REFERENCE:	Nova Bus Manuals
SECTION:	16; 24V electrical system
RS N°:	MQR 7621-227
EFFECTIVE IN PROD.:	L529 (2010MR)

SUBJECT:	Expello valve
JUSTIFICATION:	Expello valve failure may cause outage of ramp electrical 24V circuit

Figure 1 - Breaker N11690-10 Position in I.B. Box

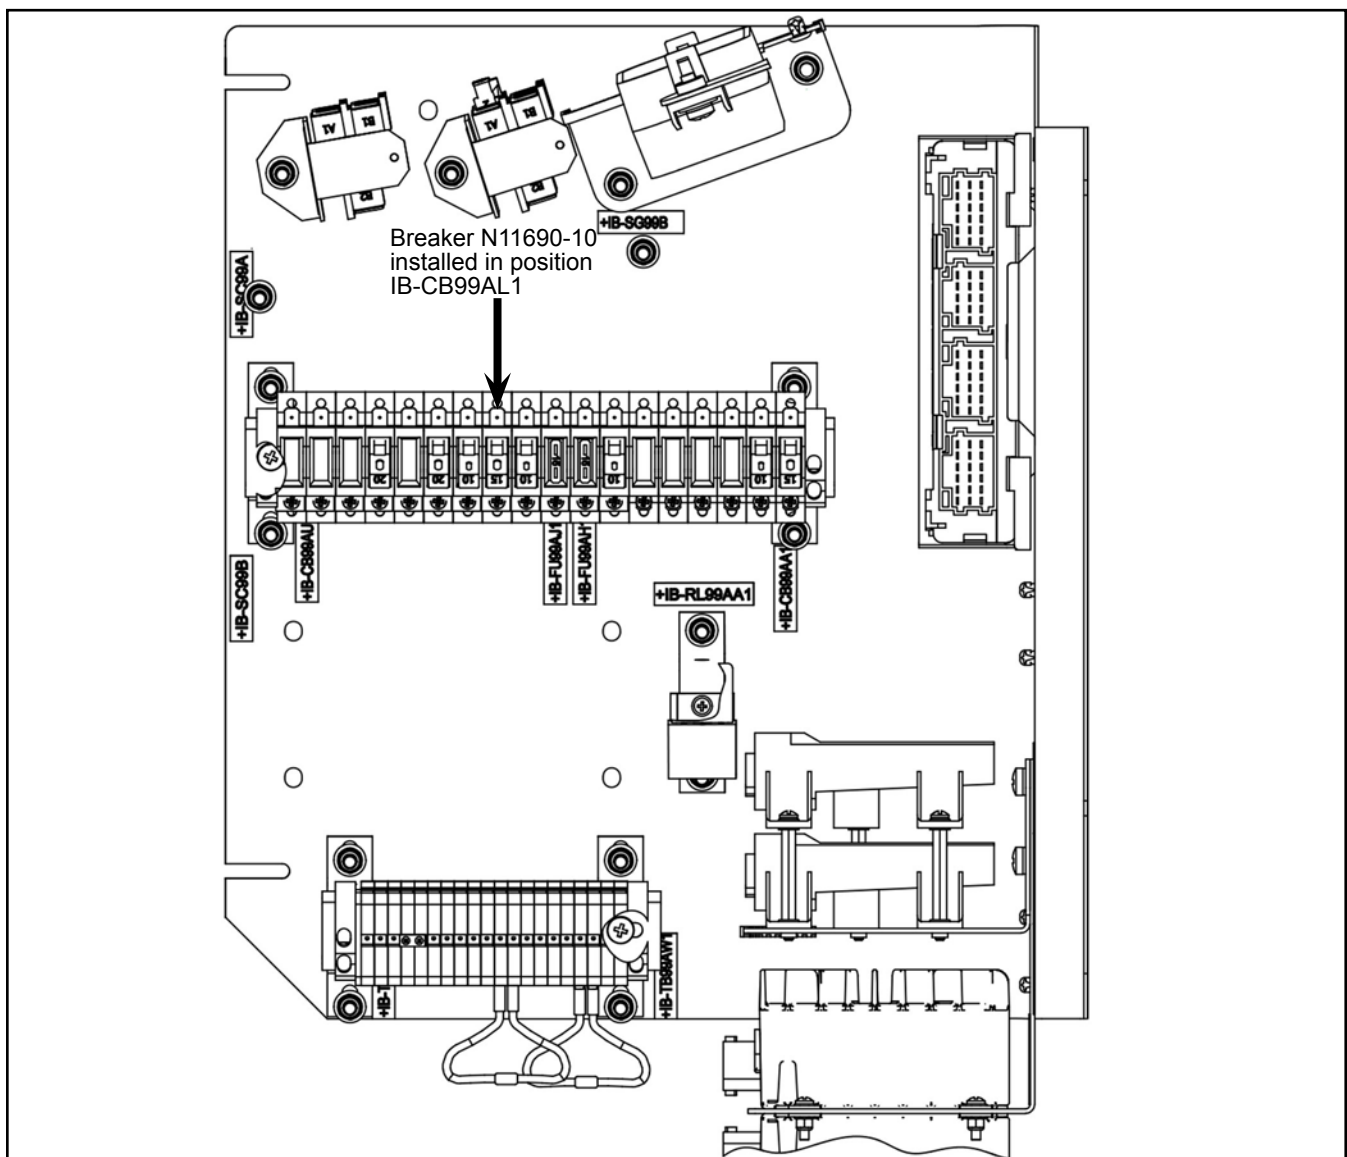
- 1.1. Open the rear battery access door and turn the battery disconnect switch to the **OFF** position.
- 1.2. Open the rear I.B. box access door.
- 1.3. Remove the 15 A breaker installed in position IB-CB99AL1 and replace with the breaker N11690-10 (10 A) breaker. See Figure 1.

- 1.4. Disconnect connector **IB-X6199A** and remove wire **99-232/RED** from position 13 in connector **IB-X6199A**. Cut terminal and install shrink tubing to tapeback the wire.
- 1.5. Connect wire **99-511/RED** in position 13 of connector **IB-X6199A** and reconnect connector **IB-X6199A**.
- 1.6. Connect the other extremity of wire **99-511/RED** to terminal block **IB-TB99AS1**.
- 1.7. Close the rear I.B. box access door.
- 1.8. Turn the battery disconnect switch to the **ON** position and close the rear battery access door. ❖
